Serial No. 09/868,182

Attorney Docket No.: CELA:082

IN THE DRAWINGS:

FIG 9

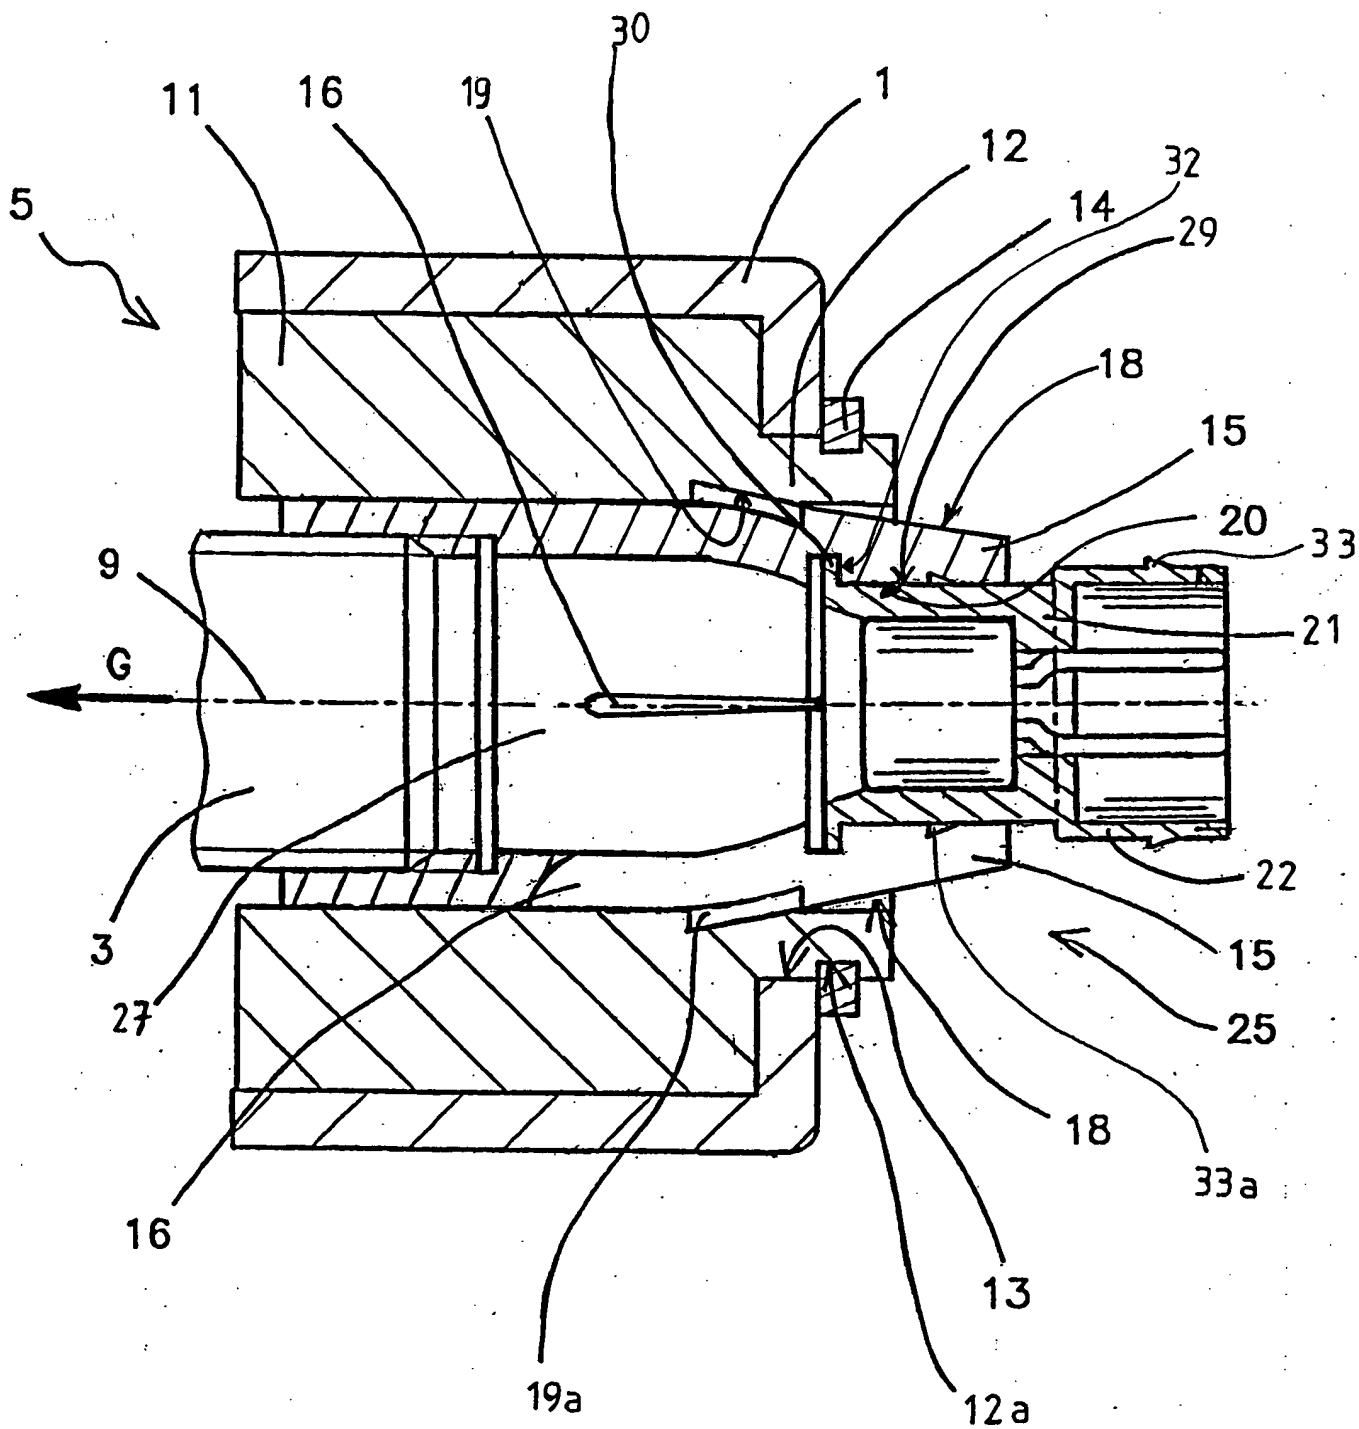
1. Section 3 of the Office Action contains an explanation why new Fig. 9 was not acceptable. Enclosed is a new Fig. 9 showing piston 21 displaced until collar 30 abuts against abutment surface 32, as mentioned by the Examiner. New Fig. 9 includes reference numeral 30 identifying the collar, reference numeral 32 identifying surface 32, and shows collar 30 abutting abutment surface 32 without a gap therebetween.

2. Section 4 of the Office Action recited objections to the original drawings. The items criticized in sections 3 and 4 are treated thusly:

A. New Fig. 9 shows piston 21 displaced until collar 30 abuts abutment surface 32.

B. Fig. 2 shows locking means 16 engaged with piston 21 at elements 33/33A, and new Fig. 9 shows element 33 in a disengaged position. Thus, Figs. 2 and 9 together show the locking means releasably engaged with the first external surface of the piston, as recited in claim 3. No change is required in Fig. 2.

C. Fig. 2 shows external profile 18 engaged with profile 19, and revised Fig. 9 shows profile 18 disengaged from profile 19. Thus, Figs. 2 and 9 together show the external profile 18, both engaged and disengaged from matching profile 19 of the matching second surface, as recited in claim 7. No change is required in Fig. 2.

Please enter the attached one (1) sheet of formal drawing, Figure 9, to replace previously proposed Figure 9.
